ST. TAMMANY PARISH

Addendum No.: 1

Bid#: 24-47-2

Project Name: River Oaks Building & Well Improvements

RIVER OAKS
BUILDING & WELL IMPROVEMENTS
PROJECT No.: TU23000160
RIVER OAKS SITE PLAN

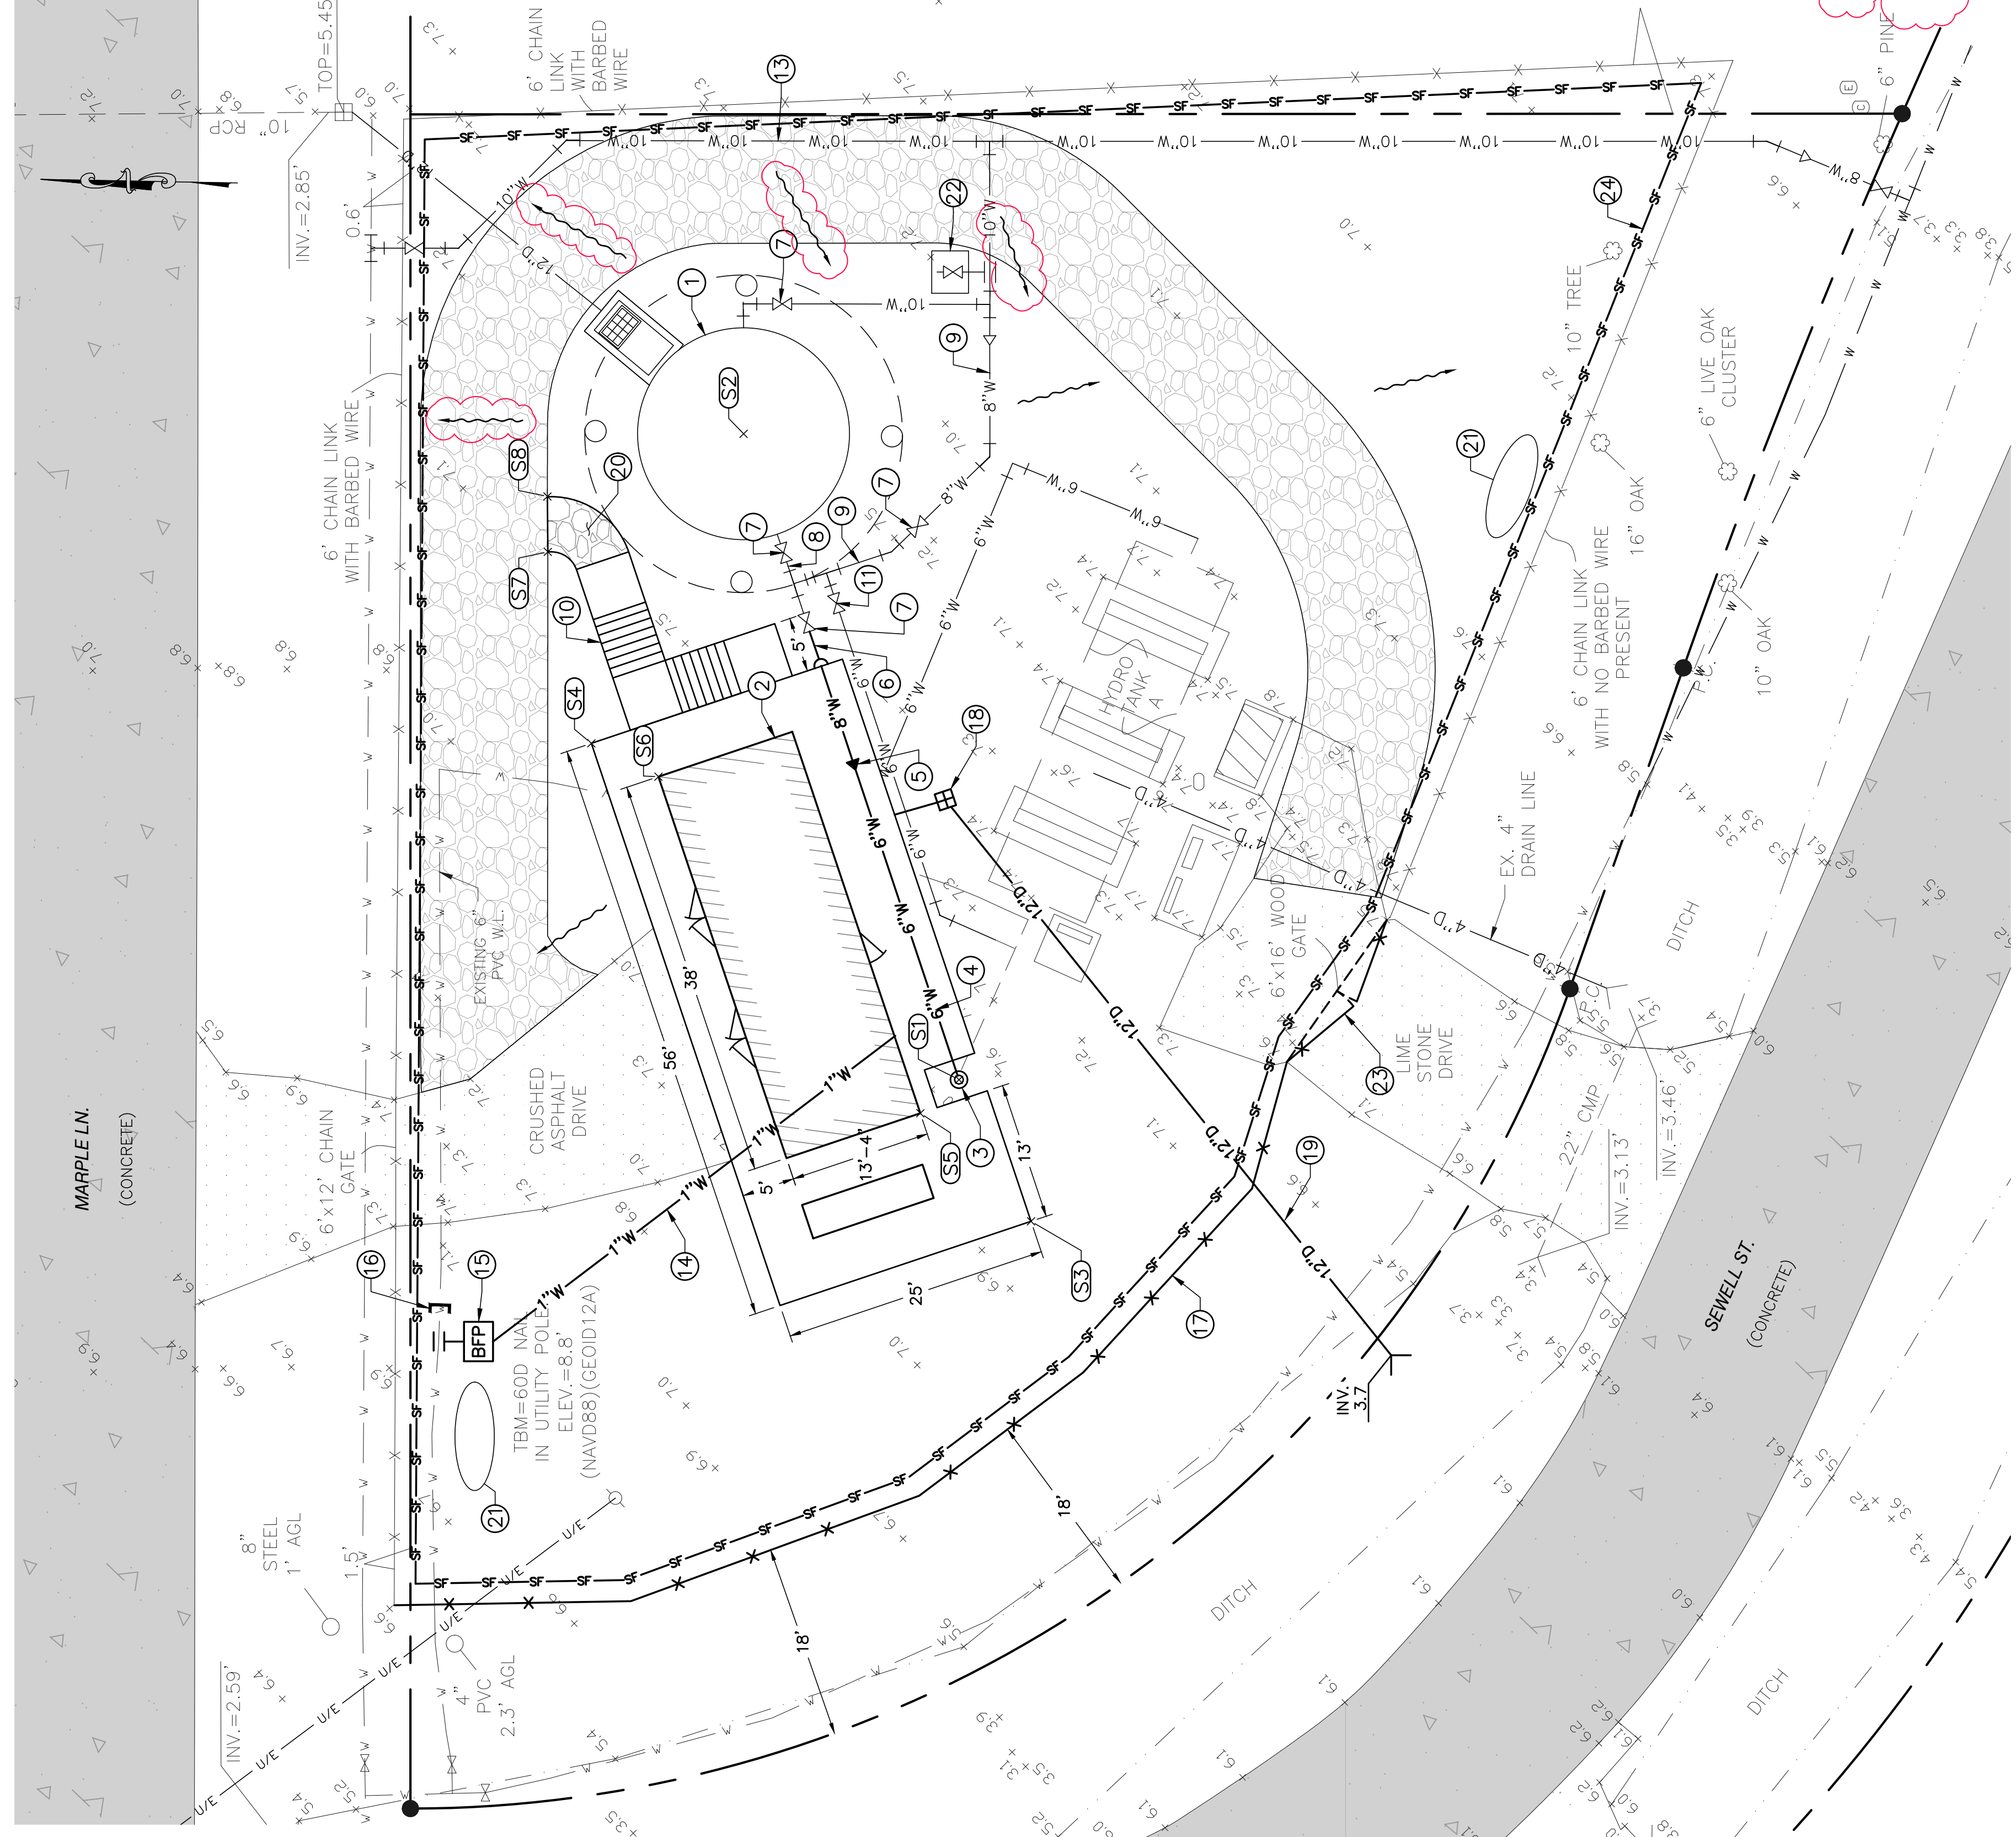
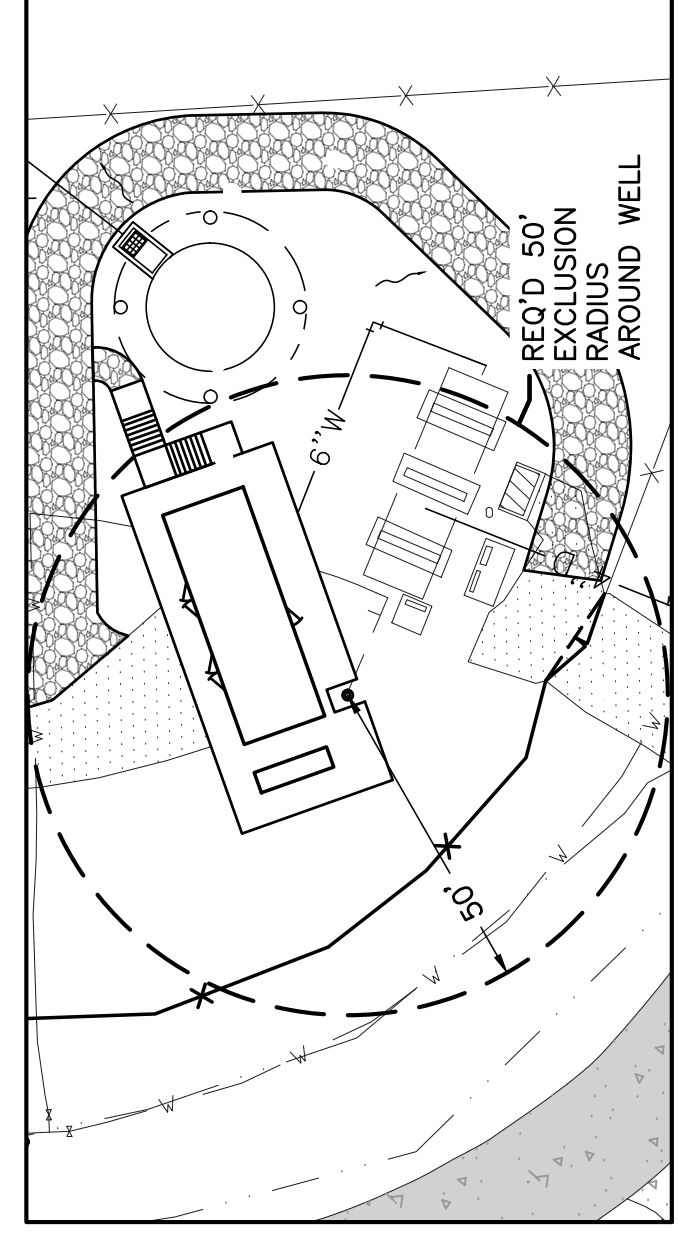
3. Drawing Sheet 5:
 - a. **Replace** Drawing Sheet 5- "River Oaks Site Plan – Addendum No. 1" with the attached.
4. Drawing Sheet 11: ADD notes as follows.

No.	DESCRIPTION OF REVISION	DATE
1	ADDED FLOW ARROW TO LEGEND AND ADJUSTED PROPOSED GRADING.	11.11.24
	ITEM TO NOTES
